UNITED STATES PATENT AND TRADEMARK OFFICE

APPLICATION NO.	FILING DATE	FIRST NAMED INVENTOR	ATTORNEY DOCKET NO.	CONFIRMATION NO.
10/658,017	09/08/2003	Joseph Cowan	03-0599 81582	4056

Office Action Summary

DETAILED ACTION

FIG. 5A

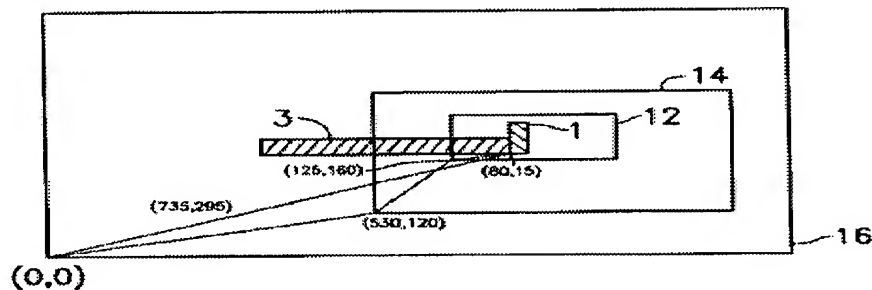
Yang clearly shows representing a net of an integrated circuit die (See, for example, Fig. 5A or 5I).

Examiner respectfully asserts that the vertex is a point at which the sides of an angle intersect, and therefore, examiner respectfully asserts that the coordinates such as the vertex (80,15) taught and seen above, by Yang, are vertices.

FIG. 5B

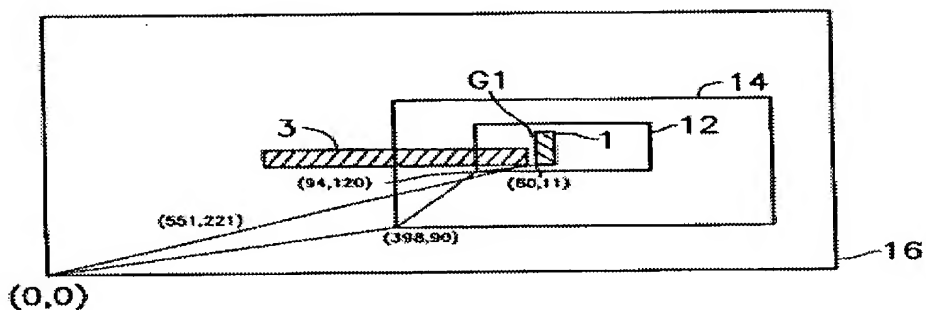
Figure 5B shows the vertices downsized 75%. Clearly, these coordinates are rounded, because $.75 \times 125$ is 93.75, and the figure shows 94. Yang clearly teaches how these coordinates

are rounded in column 3, lines 33-37. Clearly, this goes for all the coordinates (see the difference between figures 5A and 5B).

FIG. 5I

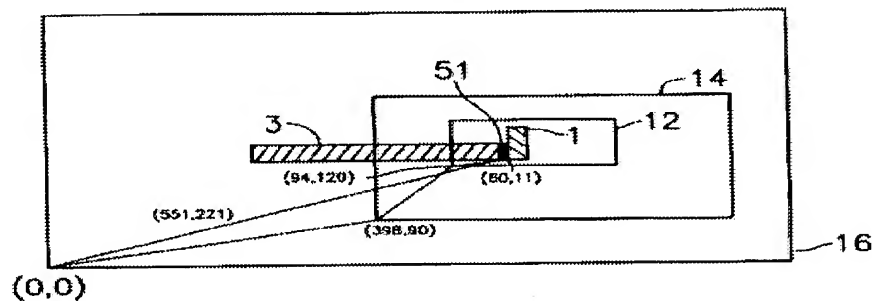
Yang clearly teaches calculating coordinates (551,221) between vertices (94,120) and (60,11), said coordinates (551,221) clearly having been rounded off after downsizing 75% (Col. 5, line 33- Col. 6, line 10).

Although Yang does not say that the rounded coordinates have been calculated having a selected resolution, Yang clearly shows and teaches that all the coordinates are rounded off to the 1's place, and therefore, Yang has clearly chosen a coordinate resolution of 1 for all the coordinates. The examiner believes that there is a difference between selecting a coordinate resolution from a plurality of different coordinate resolutions, which the claims do not require, and simply selecting one coordinate resolution. For example, *although not relied upon in the rejection*, U.S. Pat. No. 5,568,563 to Tanaka clearly teaches selecting a coordinate resolution from a plurality of different coordinate resolutions in column 8, lines 27-44. Tanaka clearly teaches a coordinate resolution of "1" and a coordinate resolution of "0.5". The examiner believes that this reference clearly shows the distinction between selecting a coordinate
